DA2025/158

13 GALLAHAR PLACE, BRIDGEWATER

2343 Proposed Dwelling, HOMES TASMANIA
13 GALLAHAR PLACE, BRIDGEWATER

FURTHER INFORMATION REQUEST - APPLICATION FOR PLANNING PERMIT (da 2025/00158) SINGLE DEWLLING - 13 GALLAHER PLACE, BRIDGEWATER

DRAWING: SITE PLAN

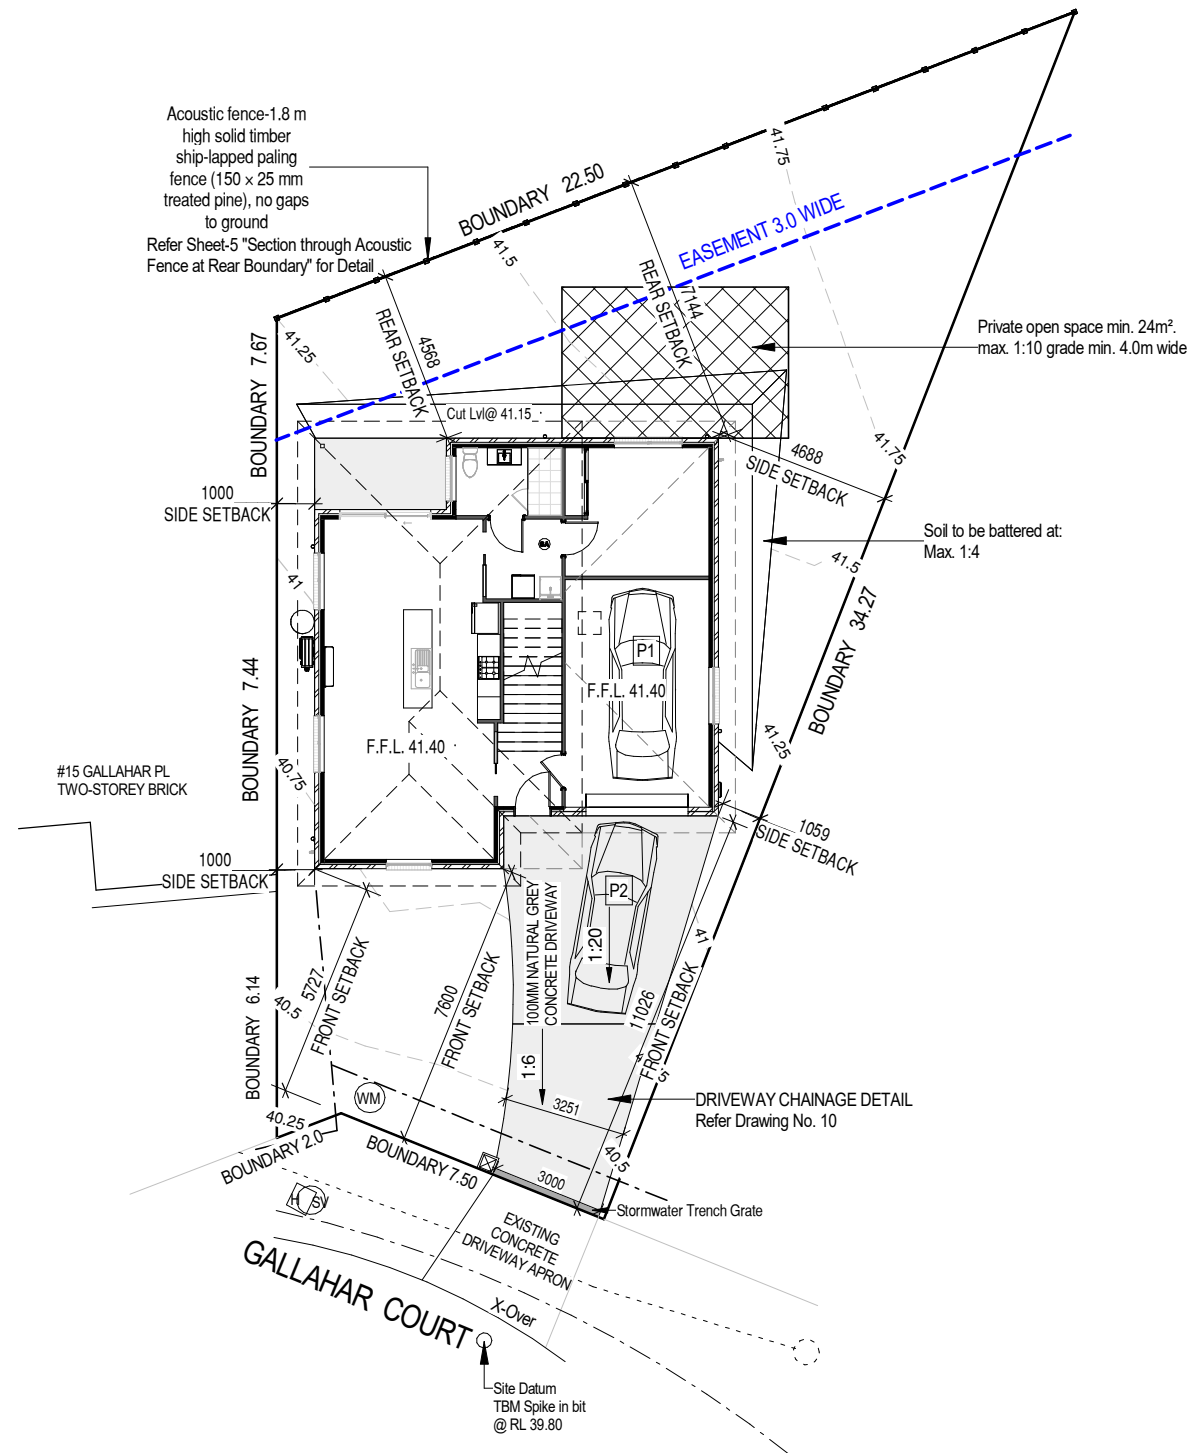
The submitted plan shows the driveway, including the crossover apron, narrowing to 2.4 metres, which does not comply with Table C2.2 of the [Parking and Sustainable Transport Code](#). This table requires a minimum width of 3 metres. Please submit a revised plan demonstrating compliance with Clause C2.6.2 A1.1 and/or A1.2, or alternatively, provide a written statement addressing the performance criteria in full.

Please provide an explanation for the proposed replacement of the concrete apron at the side (see figure below). As this work affects 11 Gallahar Place (CT26924/1708), please provide a copy of the Folio Plan and Certificate of Title, and update the application form to include this property in the development application.

Response: Please refer to the revised plans at Attachment A, specifying a minimum access width of 3m and excluding extension of the existing driveway apron from the proposal. The proposal complies with acceptable solution A1.1, and no works are proposed within the road reserve. Accessible parking is not required for a Residential use, and A1.2 does not apply.

Response: Replacement of the concrete apron affecting 11 Gallahar Place is excluded from the revised plans at Attachment A.

Figure 2 - Approximate Montage Elevation in context (Source: annotated Google Streetview and proposal plans)

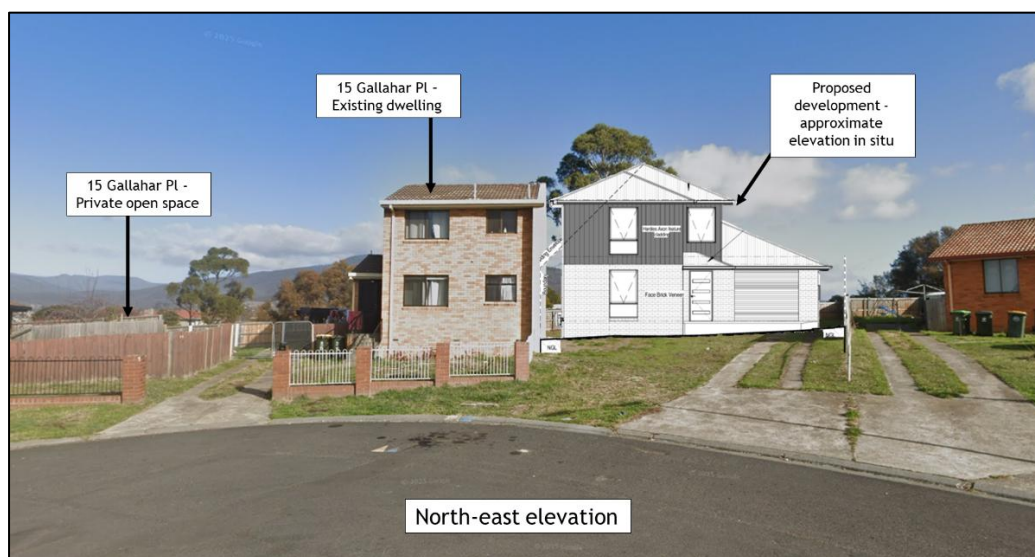
Please provide a shadow diagram showing the extent of shadowing between 9.00am and 3.00pm on 21st June to demonstrate compliance with Clause 8.4.2 P3(a)(ii) of the General Residential Zone provisions.

Response: Clause 8.4.2 P3(a)(ii) requires that the siting and scale of a dwelling must not cause an unreasonable loss of amenity to adjoining properties, having regard to overshadowing the private open space of a dwelling on an adjoining property.

The proposed dwelling is located to the north-west of the existing dwelling at 15 Gallahar Place and its ample area of private open space (Figure 1).

The existing 2-storey dwelling at 15 Gallahar Place is located between the majority of its private open space and the proposed dwelling (shown in the indicative elevation montage in Figure 2).

Owing to the siting of the proposed dwelling to the north-west, no overshadowing of the adjoining private open space would be caused during the morning on the winter solstice. The extent of any additional shading during the afternoon would be marginal, relative to that caused by the adjoining dwelling. Therefore, any potential shading impact from the proposed development would not be considered to cause an unreasonable loss of amenity to the land at 15 Gallahar Place. The proposal complies with clause 8.4.2 P3(a)(ii) and in this case, shadow diagrams are not considered to be warranted.

Figure 3 - Embankment (Source: annotated LISTmap, Google Streetview)

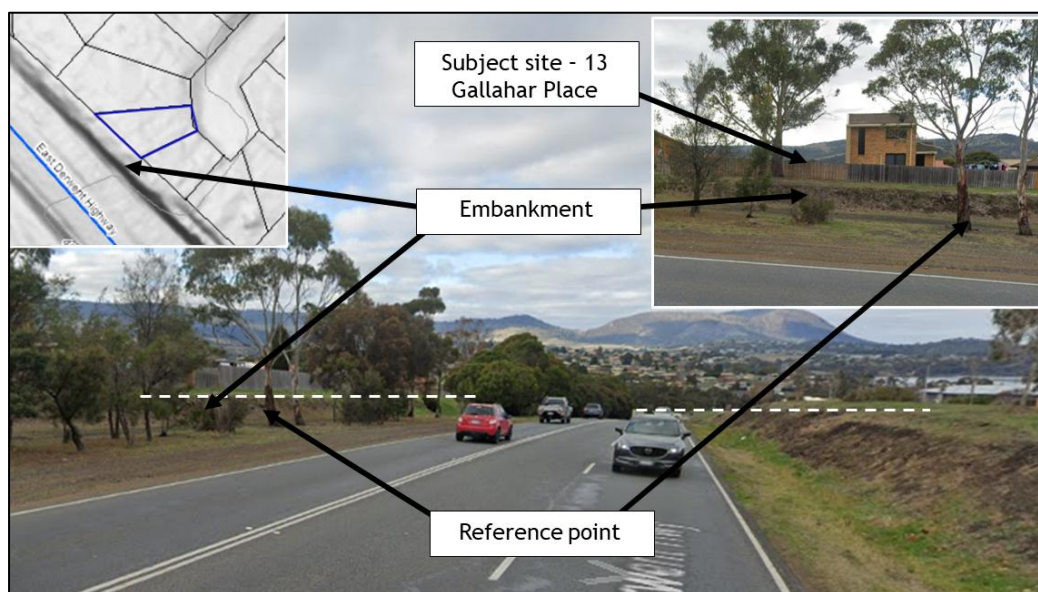
Response: The proposed development has a slightly reduced setback from the East Derwent Highway boundary relative to dwellings on the adjoining properties. A response against the performance criteria is provided as follows.

The proposal has been revised (refer to Attachment 1) to include screening and building design measures to minimise any adverse effects from emissions from traffic on East Derwent Highway, in compliance with P1. In particular, an acoustic fence (ship-lapped 15mm timber planking) is proposed along the south-western boundary (l) and the dwelling is proposed to be constructed to meet Australian Standard AS2107 (i).

Although the immediate area is relatively flat, the site is slightly elevated above the level of the road (a), owing to the situation of the carriageway within a cut (Figure 4). The height of the embankment relative to traffic on the road, combined with the substantial separation of the carriageway ~23m from the site boundary (Figure 3), provides a degree of noise attenuation (c). The proposed dwelling setback of more than 4.5m from the rear boundary further extends the separation from highway traffic noise sources, noting that non-habitable rooms (bathrooms) are located in the corner of the dwelling closest to the highway ((b) and (d)).
